3 December 2024

Deg Tegh Fateh Sikh Society
C/- Baseline Group Limited
Attention: Sally Elford

517 HAMPTONS ROAD (RC245337) TRANSPORT RESPONSE TO COUNCILS RFI'S

Figure 1: Indicative location (yellow) of overflow grass parking.

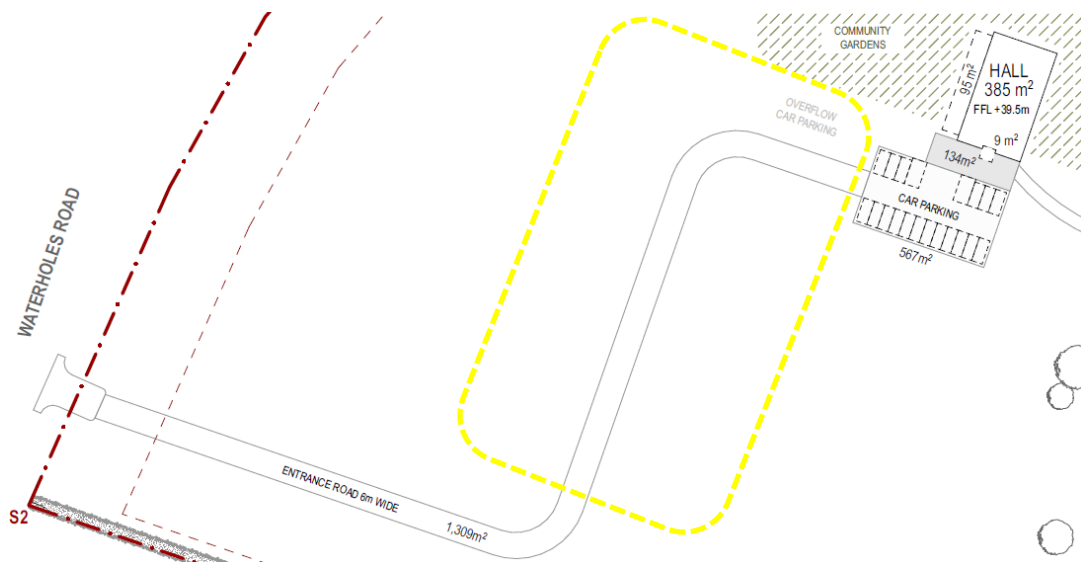
10. With regard to TRAN-R8 and TRAN-MAT4.8: please provide further details on how parking, circulation and queuing will be controlled and contained within the site during large events.

10. As outlined in the ITA and above, informal parking areas will be provided for overflow parking (only anticipated once a week). Flexibility is sought to allow parking to be rotated to avoid wear of the grass surfaces so as not to generate mud / dust but will generally be at the northern end of the access (refer to Figure 1). These areas will be mowed / maintained and any gates opened in advance. Drivers will be advised of the location by a moveable "park here" sign on the access, to direct people to the overflow area being used on any given occasion.
11. The site is large and the access is some 200m long and will be 6.0m wide providing for two way flow. The location of the building and gardens (to the rear of the car park) is such that it will encourage everyone to move well into the site to look for an overflow car park.

Given the length of the access and site layout, congestion is not likely to occur near the road boundary / site entrance and adequate queuing space will be very readily available.

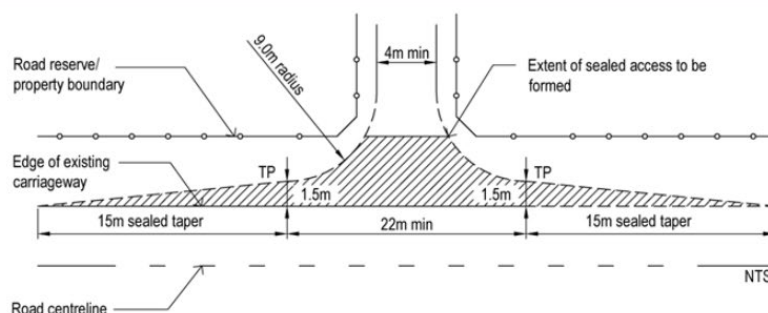
11. Please provide a safe systems assessment from a suitably qualified transportation engineer that addresses the following for the crossing on Waterholes Road.

13. As outlined in the ITA, the vehicle crossing to Waterholes Road is existing. This was formed and constructed as part of the Christchurch Southern Motorway. This was undertaken at the same time as the realignment of Waterholes Road on the approach to the intersection with Hamptons Road. The access was specifically provided for access to 860 Waterholes Road. It is already formed and sealed and at least 6.0m wide with additional width where it crosses the culvert. These changes have been subject to detailed road safety audits undertaken at the time of the recent realignment and construction and are formed to a high standard.

14. The location is already in the most appropriate point for access, as was determined at the time of the road re-alignment. There would be no benefit in re-considering this matter given it has already been highly scrutinized by the road controlling authority at the time.

15. It is noted that the swale near the vehicle crossing is reasonably shallow and would have been designed to be appropriate noting the 80km/h speed limit when it was constructed as part of the realignment works. Given any vehicle turning into the site would have slowed down to undertake the turn (<10km/h), in the very unlikely event that they were to miss-judge the turn and miss the vehicle crossing / slip off the culvert into the swale, this would be at low speeds and likely to result in property damage / non-injury type crashes only.

SITE PLAN
A1-005

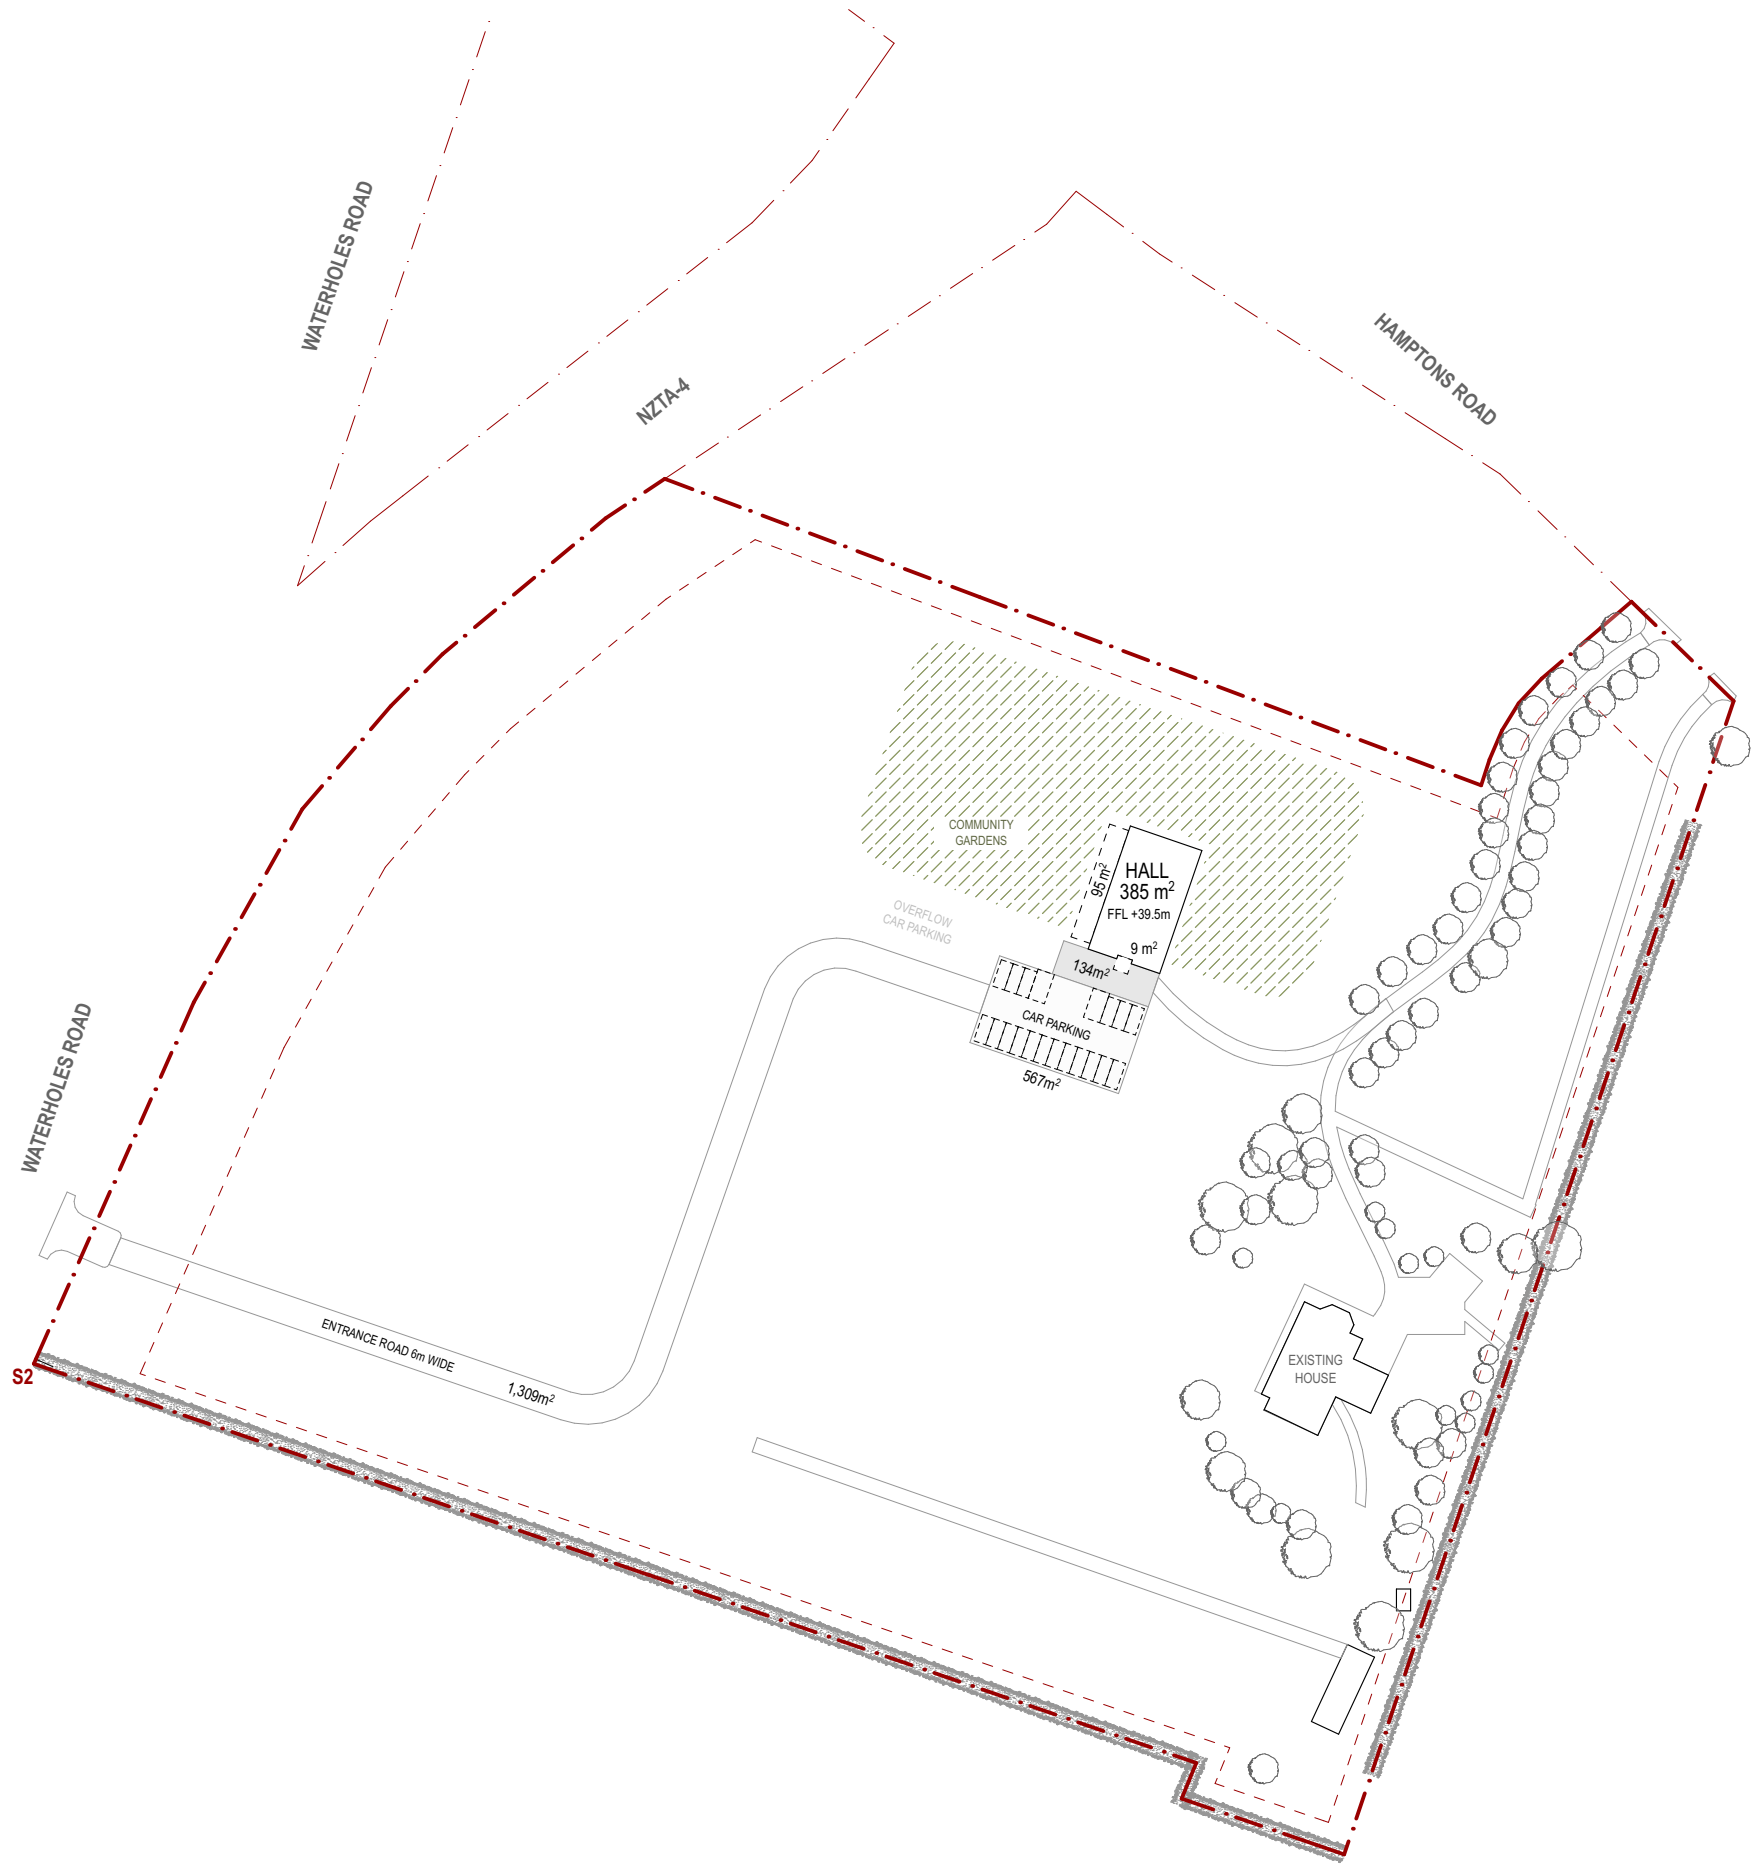
5. With regard to TRAN-R6 and TRAN-REQ9, please provide the dimensions of the parking spaces and manoeuvring aisles, as well as vehicle tracking for any non-complying parking spaces.

2. An amended site plan has also been prepared and a copy is provided in **Attachment 1**. This includes dimensions for the formed car park layout and a reduction to 20 formed and marked car parks. This will still meet the anticipated demand for most of the week (refer to Figure 2 of the Integrated Transport Assessment). For the maximum parking demand, at the main Sunday service this would result in 53-96 vehicles parking informally on the grass areas. Flexibility over the locations is sought so as not to wear-out the grass in any one area but these would be generally at the northern end of the access (shown indicatively below).

3. Refer to paragraph 14 of the ITA which sets out that the car parking dimensions and the plan in Attachment 1 which shows they comply with the District Plan requirements. All car parks will have complying manoeuvring because of the access width, and location.
